BAL-001-~~1~~2 – Real Power Balancing Control Performance Standard Background Document

February 2013

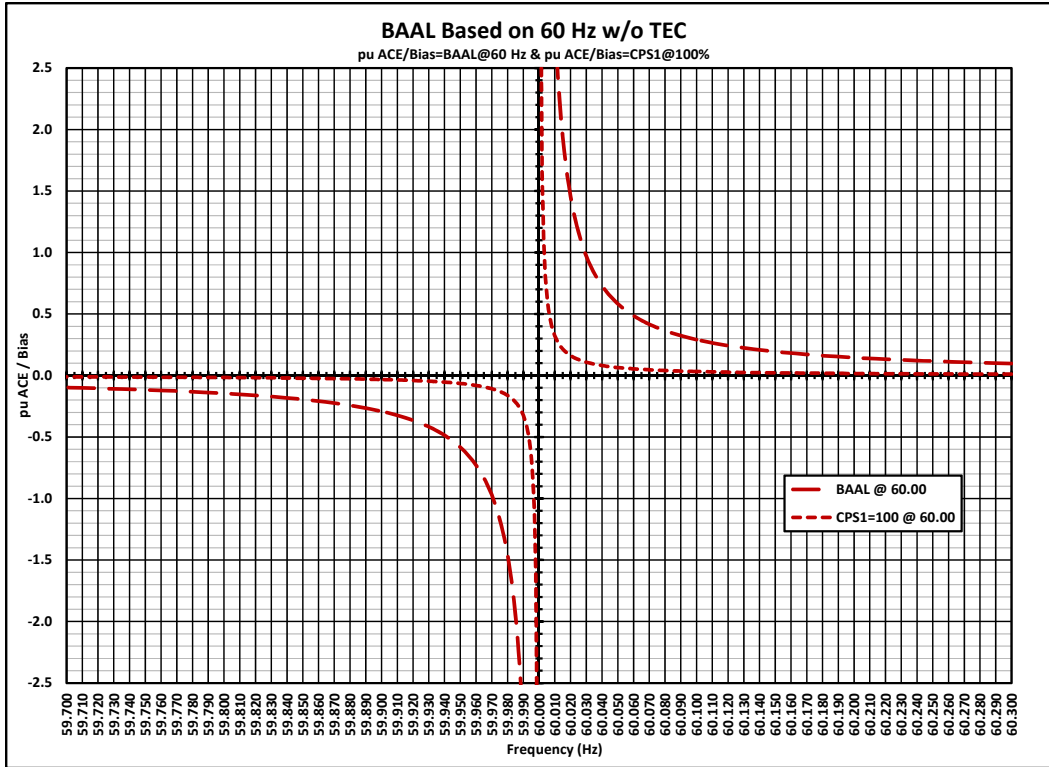
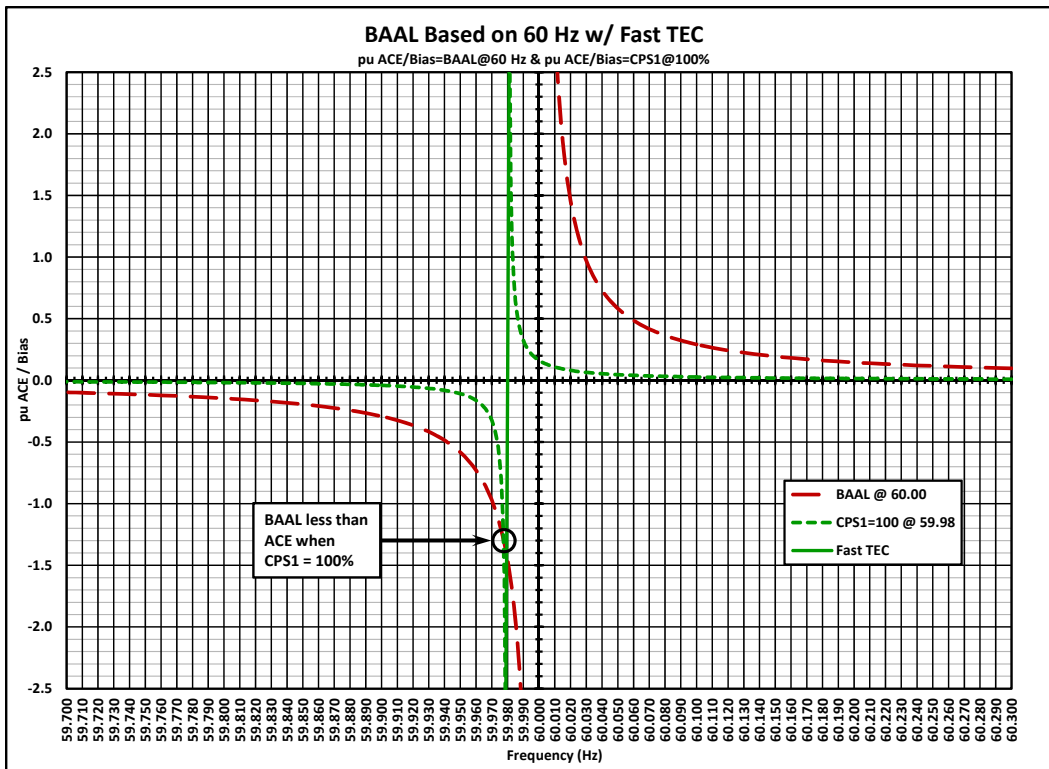
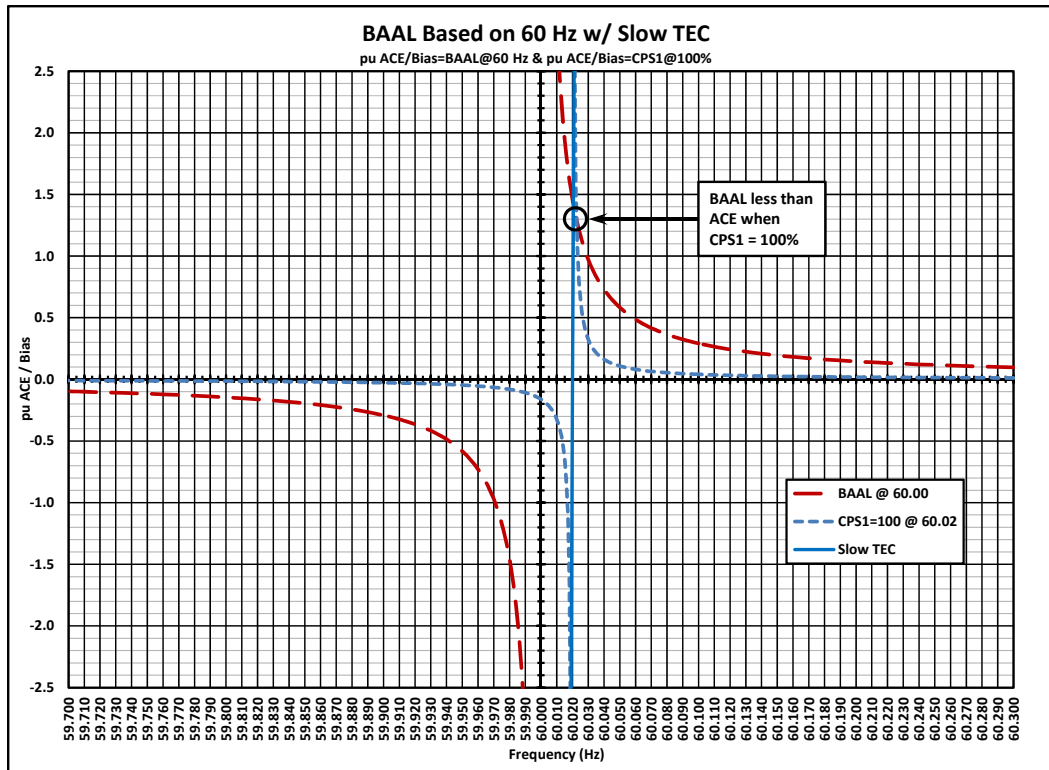
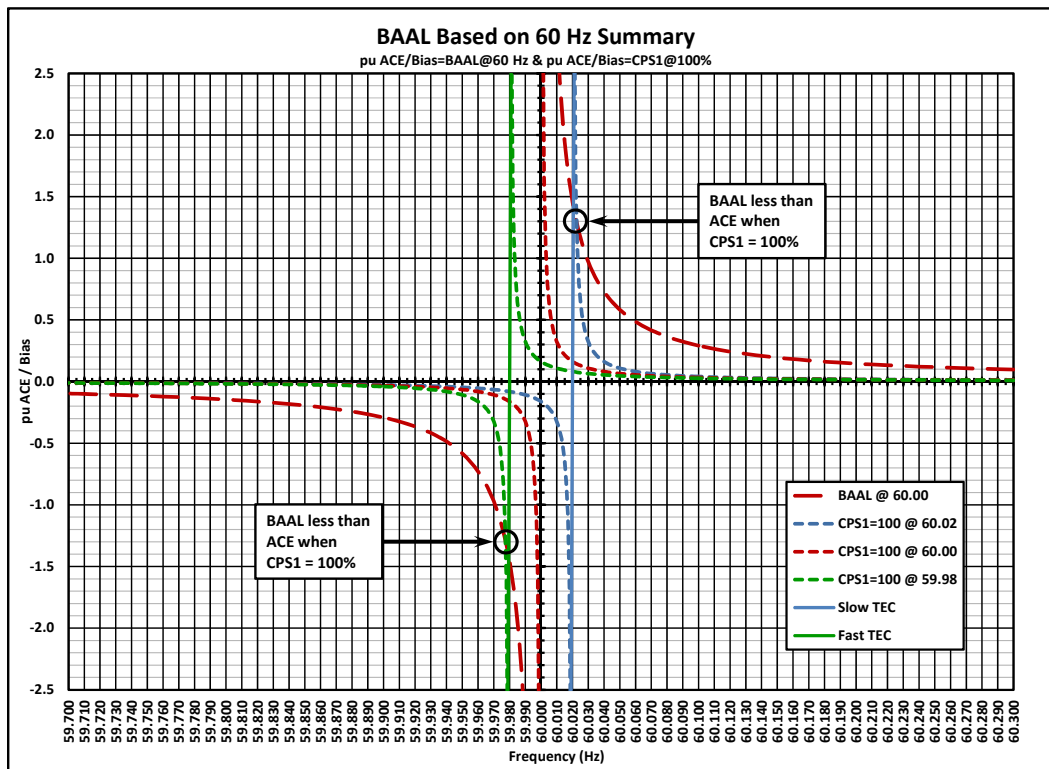
The first four graphs show the conflict that is created while performing TEC. Under TEC the BAAL limit crosses both the CPS1 = 100% line and the Scheduled Frequency Line indicating the conflict between BAAL, CPS1 and TEC when BAAL is based on 60 Hz.

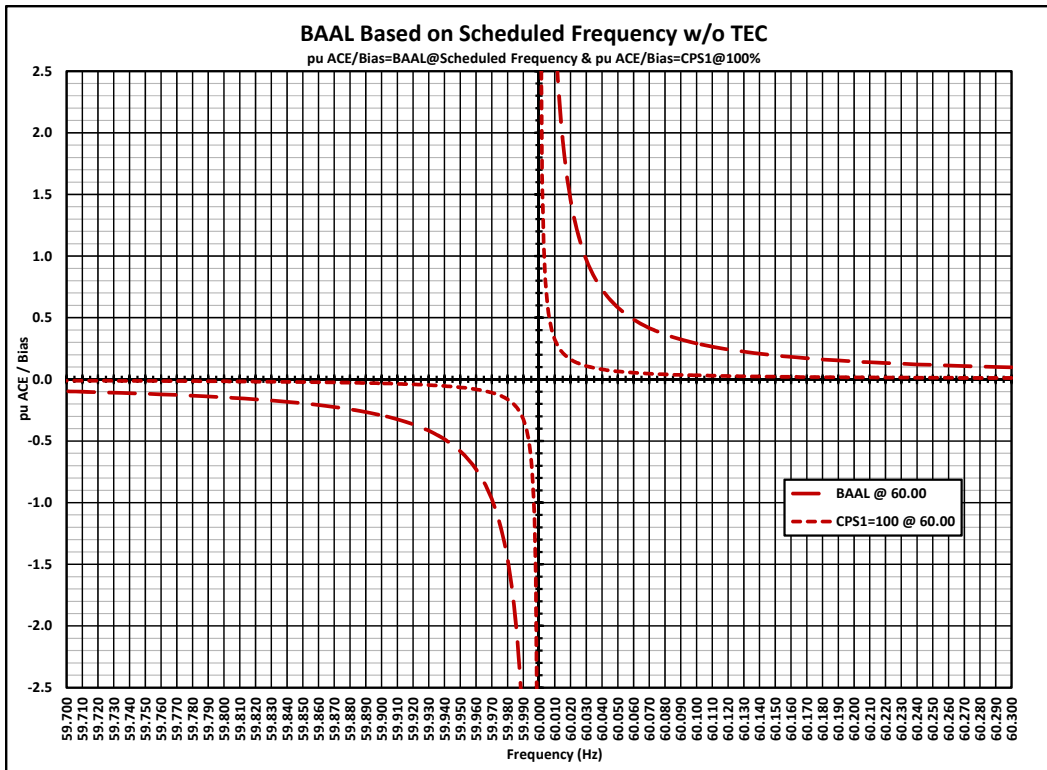
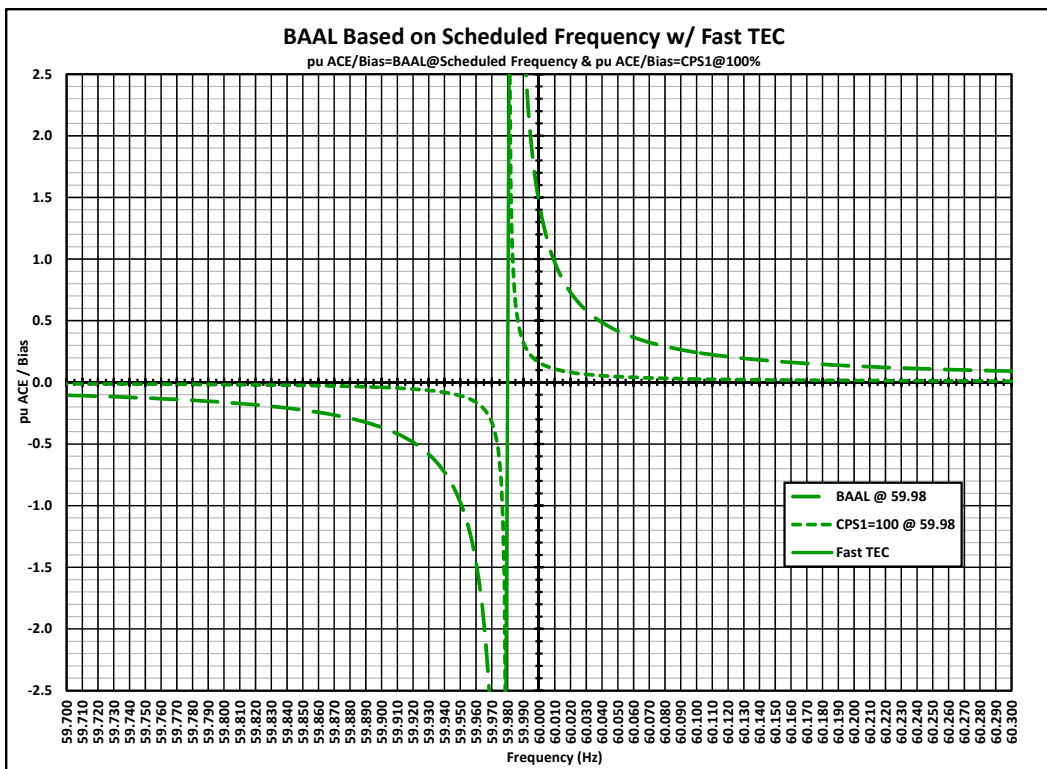
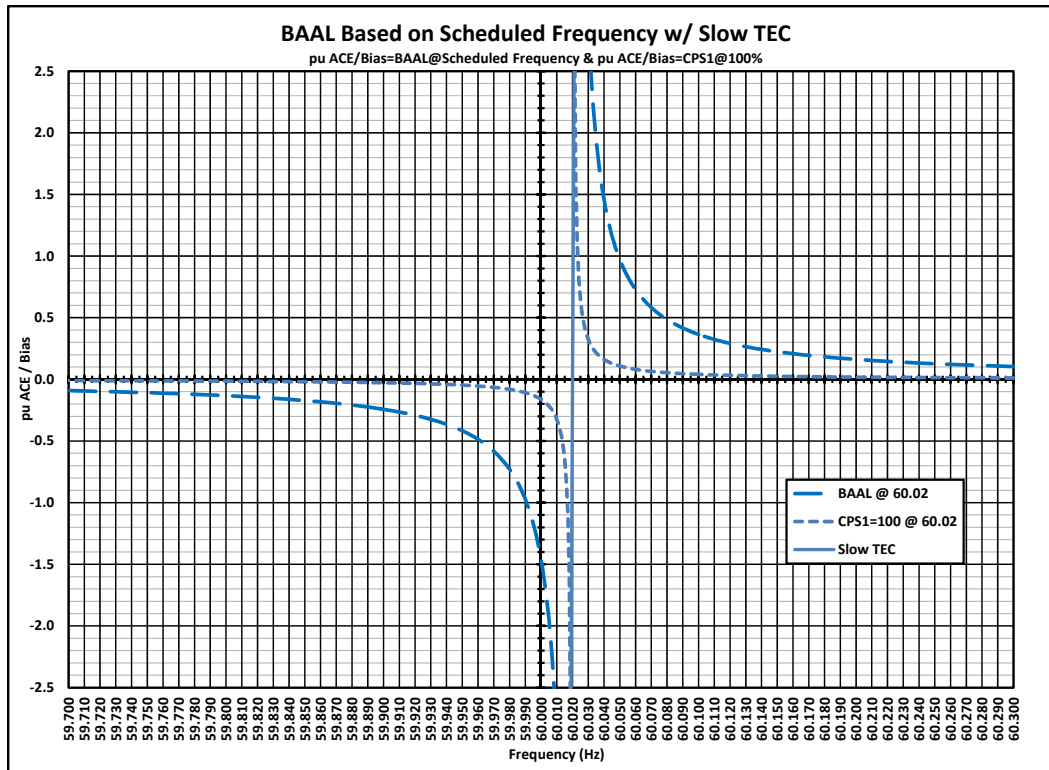
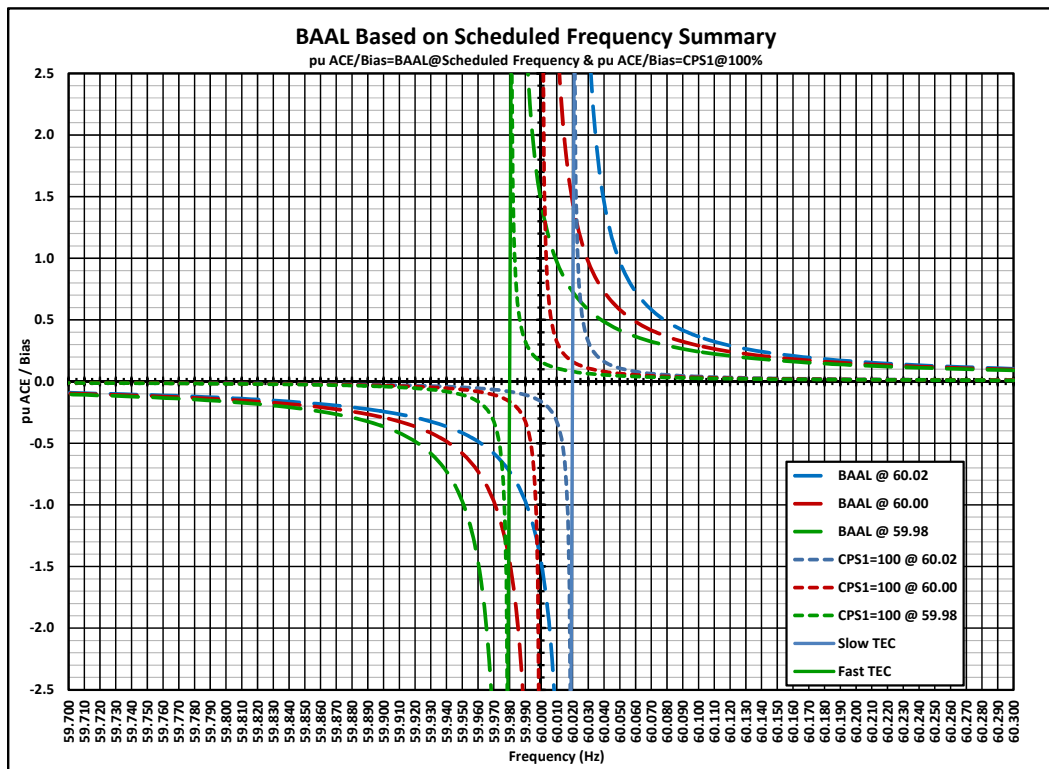
The next four graphs show how this conflict is resolved by using Scheduled Frequency as the base for BAAL. When BAAL is determined in this manner both conflicts are resolved and do not appear with the implementation of TEC.
